# DESIGN REVIEW

for  
REMEDIAL ACTION  
at  
C.P.S./MADISON SITES

for  
New Jersey Department  
of Environmental Protection

by  
CH2M HILL

Figure 1.1  
NJDEP Preliminary Design and  
Recommended Facility Locations

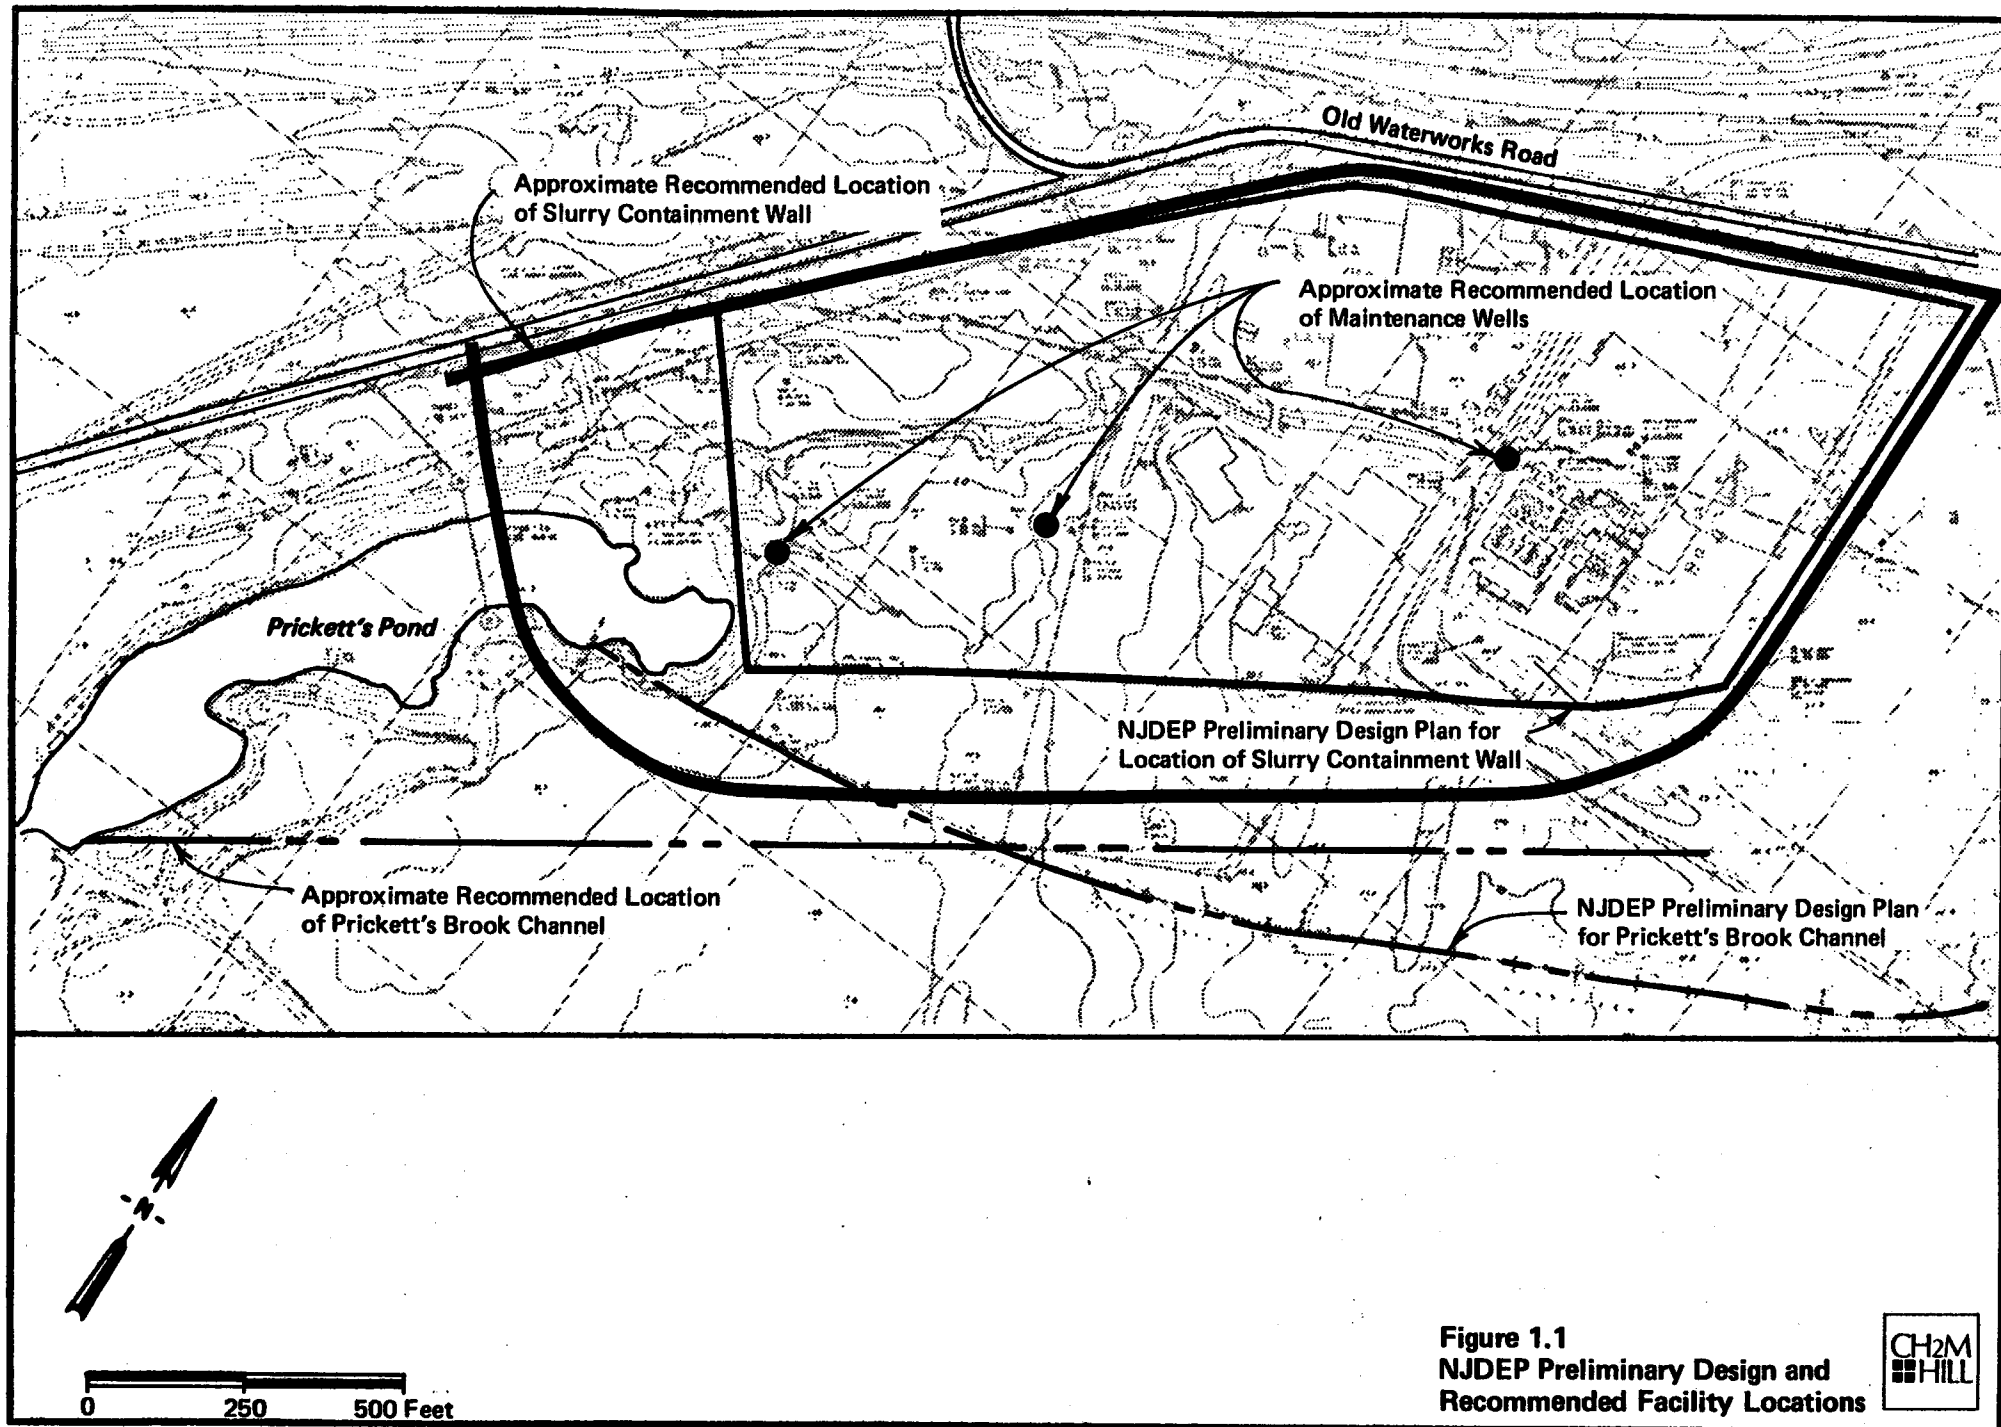
Proposed modifications to the NJ DEP preliminary design plans include an extension of the slurry containment wall to the south and southwest, alternate trench backfill material along Old Waterworks Road, installation of three float-controlled, 120-gallon per minute maintenance wells inside the slurry containment wall, and modifying the route for the relocation of Pricketts Brook.

The recommended location for the slurry containment wall would enclose the entire area of known contamination, thereby eliminating the need for decontamination wells outside of the slurry containment wall. The use of alternate backfill materials would reduce constructability problems. The recommended relocation of Pricketts Brook would minimize excavation quantities, would reduce construction related health and safety hazards, would reduce the impact to the surrounding environment, and is necessary to accommodate the recommended location of the slurry containment wall. The locations of these facilities are shown in Figure 1.1. The NJ DEP preliminary design plans are shown for comparison.

Figure 3.2  
NJDEP Preliminary Design and  
Recommended Pricketts Brook Relocation

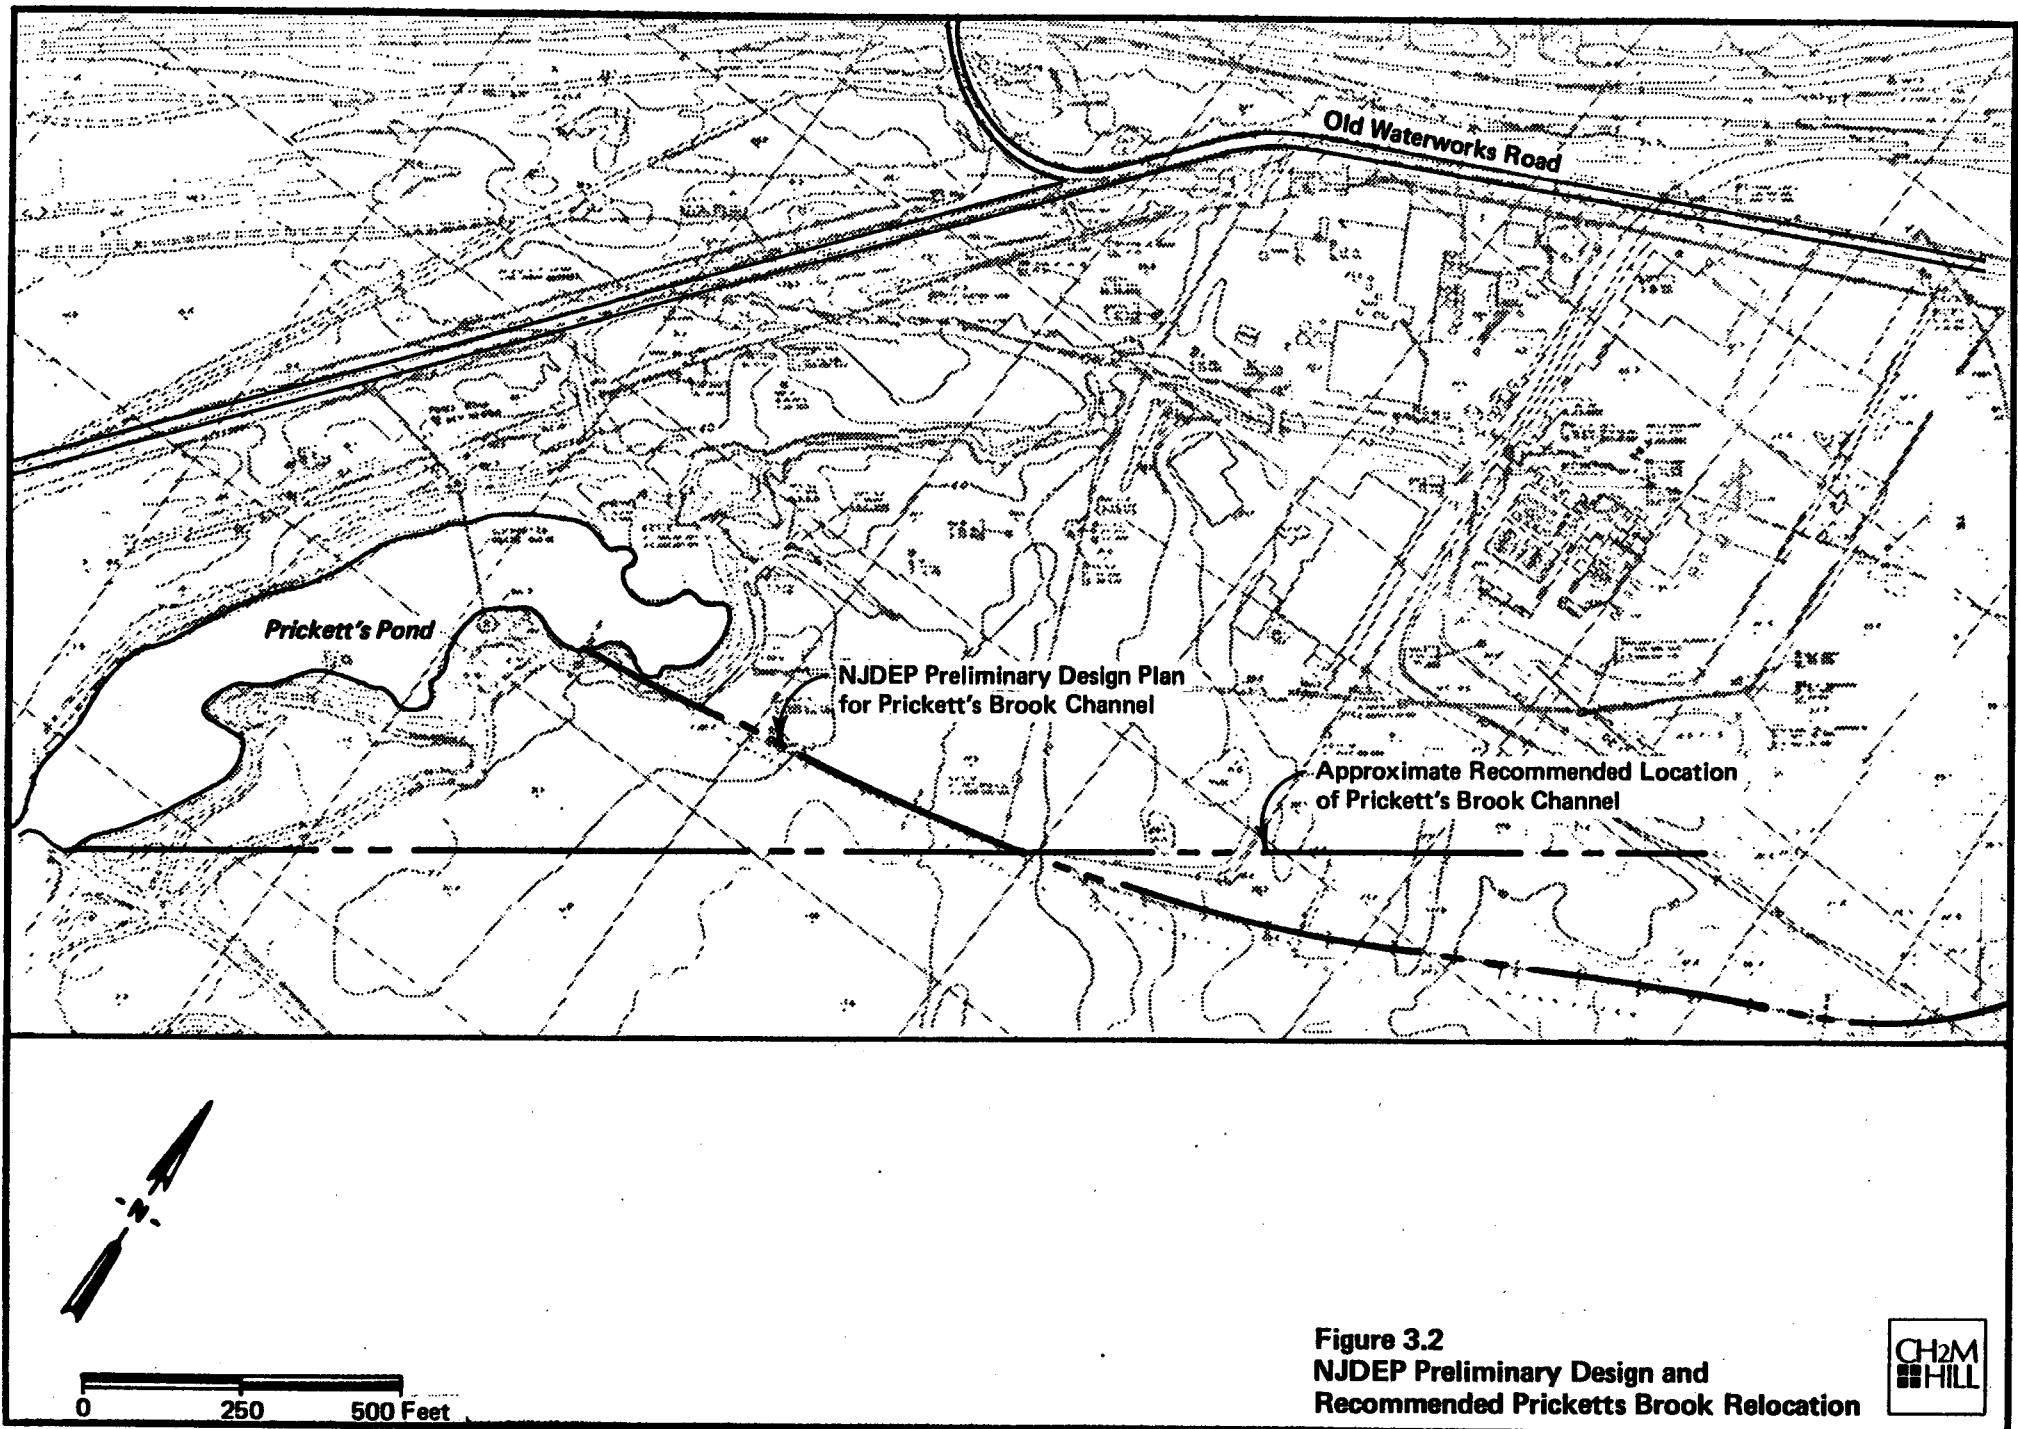
The proposed channel alignment shown on the preliminary plans is expected to adequately handle runoff from the upstream drainage basin in accordance with the design objectives. However, difficulties in construction are anticipated with this alignment.

At the upstream end of the proposed channel, the new channel extends into a boggy area located on Rebel One Corporation property. Improved drainage conditions may adversely affect natural water levels in the bog. Construction of the new channel will also cause considerable disturbance to vegetation within both a wooded area and the bog.

The surface grades in the northeastern portion of the proposed channel are relatively high, exceeding 36 feet above mean sea level. Construction of the new channel will result in an unnecessarily deep and wide excavation. The quantity of materials to be excavated can be substantially reduced if the new channel were constructed further to the northwest in this area.

It is not the intent of the new channel to improve or repair the conditions within the existing channel. If the new channel were to depart from the existing channel about half-way along the rear of the CPS site, the disturbance to the vegetation within the bog and wooded area on Rebel One Corporation property would be avoided, and excavation quantities minimized. The existing 90-degree bend and severe gulleying at the eastern corner of the CPS site would not be changed, however.

The alignment should pass near the rear fence line of the Madison Industries site and discharge downstream of Pricketts Pond to facilitate sediment removal and decontamination. The recommended realignment is shown in Figure 3.2.

**Figure 4.1**  
**NJDEP Preliminary Design and**  
**Recommended Slurry Containment Wall Locations**

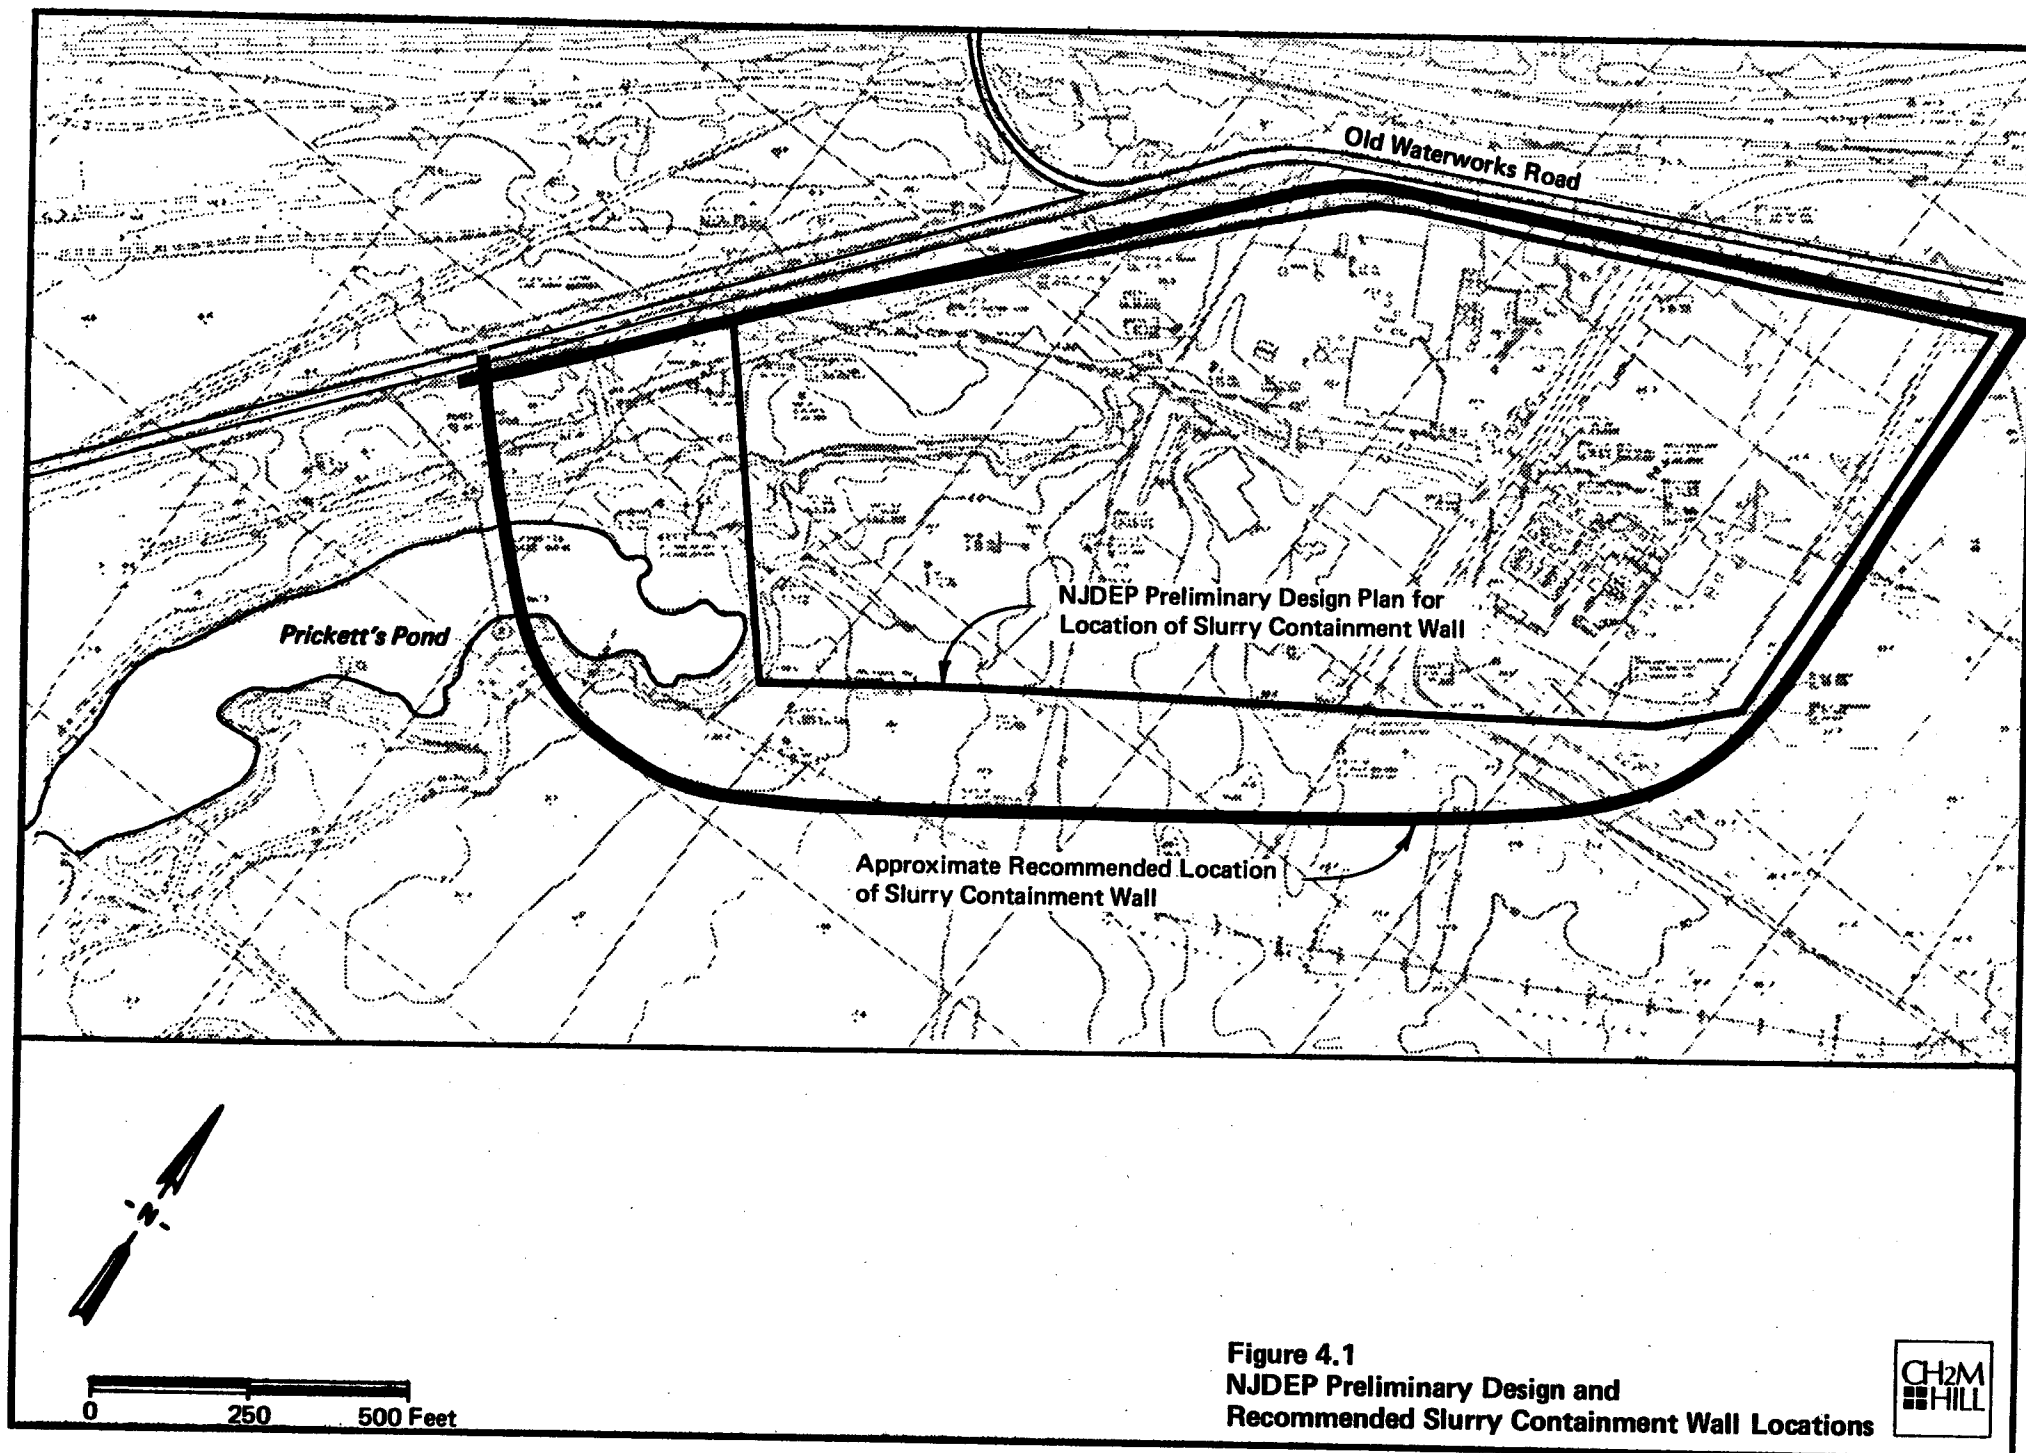
The proposed alignment of the wall in the rear of the Madison Industries plant is located relatively close to an existing building and will cause substantial disruption of the plant storage yard during construction. Because of surface grading changes needed to accommodate the wall, and because of potentially poor subgrade support, the permanent usable yard storage area at Madison Industries will be substantially reduced if the wall cuts through the center of that area. Instead, the wall could be located near the rear of the storage yard, parallel to the proposed Pricketts Brook channel.

The proposed wall alignment has discrete points where the alignment changes direction, making either very sharp or very slight angles. Where these angles are excessively acute or obtuse, the construction equipment will not readily be able to excavate and backfill adjacent sections of the wall. Smooth, large-radius curves would eliminate very slight angles and increase acute angles to approximately 90 degrees. The recommended locations for the proposed slurry containment wall and Pricketts Brook channel are shown in Figure 4.1. The original NJ DEP proposed locations are also shown.

Special backfill materials should be provided along Old Waterworks Road where the proposed slurry containment wall crosses the plant access roads and the railroad spur lines. Concrete backfill placed in sections or "panels" approximately 50 feet long is recommended. The concrete backfill sections should extend at least 25 feet beyond the edge of the road or railroad limits.

The wall alignment should be extended further to the southwest through the center of Pricketts Pond to enclose the areas of greatest contamination. The south portion of the wall should be located parallel to the proposed Pricketts Brook channel and the northwest portion should be located parallel to the existing dirt road. Along Old Waterworks Road, the wall should be located at least 40 feet away from the C.P.S./Madison plant buildings. Excessively obtuse or acute angles should be eliminated by providing large-radius curves where the wall alignment changes directions.
